MEMPHIS AND SHELBY COUNTY OFFICE OF PLANNING AND DEVELOPMENT
STAFF REPORT **#9**

CASE NUMBER: P.D. 09-322 **L.U.C.B. MEETING:** October 8, 2009

DEVELOPMENT NAME: Memphis College of Art Planned Development

REQUEST: A second residence hall

Outline Plan

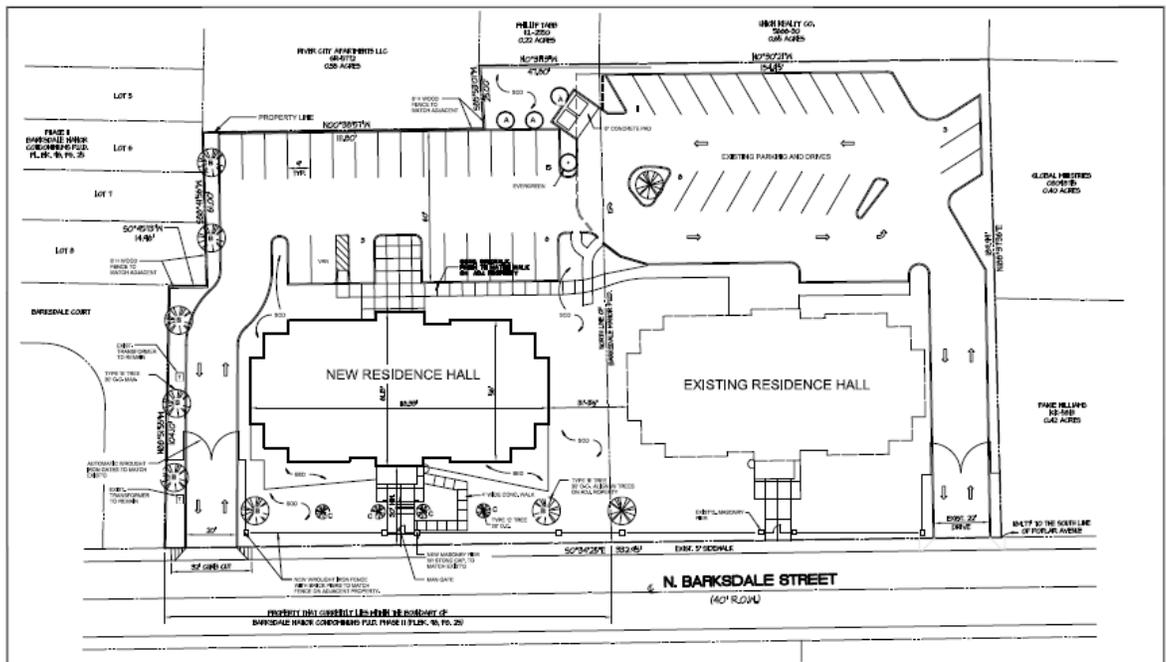
3. The City Engineer shall approve the design, number and location of curb cuts.
4. The developer's engineer shall revise the proposed outline plan to reflect the curb cut configuration previously agreed upon in consultation with the City Traffic Engineer.

8. The proposed gate locations do not meet the requirements for setback, and no turn-around has been provided on the outline plan.
9. Adequate queuing spaces in accordance with the current ordinance shall be provided between the street right-of-way line and any proposed gate/guardhouse/card reader.
10. Adequate maneuvering room shall be provided between the right-of-way and the gate/guardhouse/card reader for vehicles to exit by forward motion.

- III. Access, Circulation and Parking:
 - A. Permit two curb cuts as shown on the outline plan, subject to the review of the City Engineer for design and location.
 - B. The developer's engineer shall revise the proposed outline plan to reflect the curb cut configuration previously agreed upon in consultation with the City Traffic Engineer.
 - C. Permit security gates at each entrance as shown on the outline plan.
 - D. Provide internal circulation between the two buildings.
 - E. Provide a minimum of 46 parking spaces.
 - F. Any existing nonconforming curb cuts shall be modified to meet current City Standards or closed with curb, gutter and sidewalk.
 - G. All existing sidewalks and curb openings along the frontage of this site shall be inspected for ADA compliance. The developer shall be responsible for any reconstruction or repair necessary to meet City standards.
